# Power Back Door System Has Abnormal Closing Operation

YEAR(S)	MODEL(S)	ADDITIONAL INFORMATION
2008 - 2013	Highlander, Highlander HV

### REVISION NOTICE

The information contained in this bulletin supersedes SB No. T-SB-0038-15.

Figure 1.

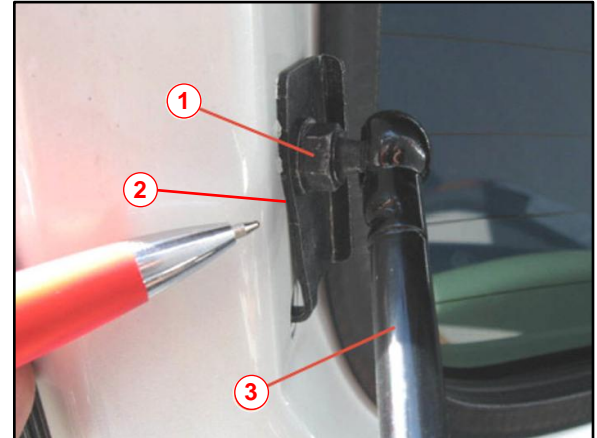
1. Visually inspect the Lift Arm Stud and Power Back Door Bracket for bends or damage as shown.

Are the Power Back Door Bracket and Lift Arm Stud damaged?

3. Measure the current torque of the Lift Arm Stud. Is the torque < **10N\*m (102 kgf\*cm, 89 in\*lb)**?

- **YES** — Go to the Repair Procedure.
- **NO** — Continue to step 2.

- **YES** — Go to the Repair Procedure.
- **NO** — Continue to step 4.

Figure 3.

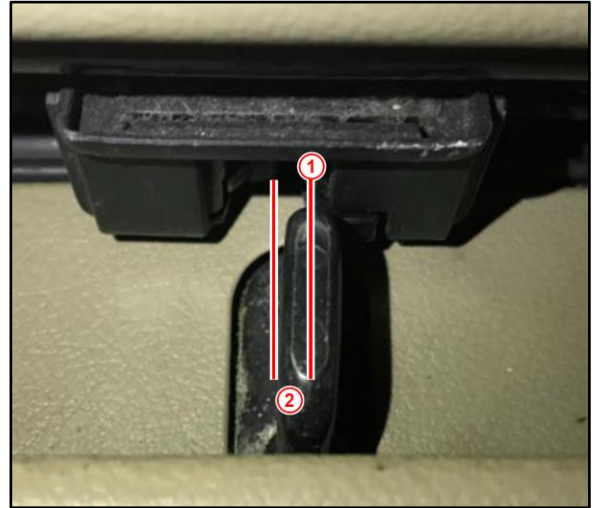
- B. Measure the center mark of the latch opening and compare it to the center line of the striker.

Is the latch < or = 3.1 mm from the center line of the striker?

- **YES** — This bulletin does NOT apply. Continue diagnosis using the applicable Repair Manual.
- **NO** — Continue to the Repair Procedure.
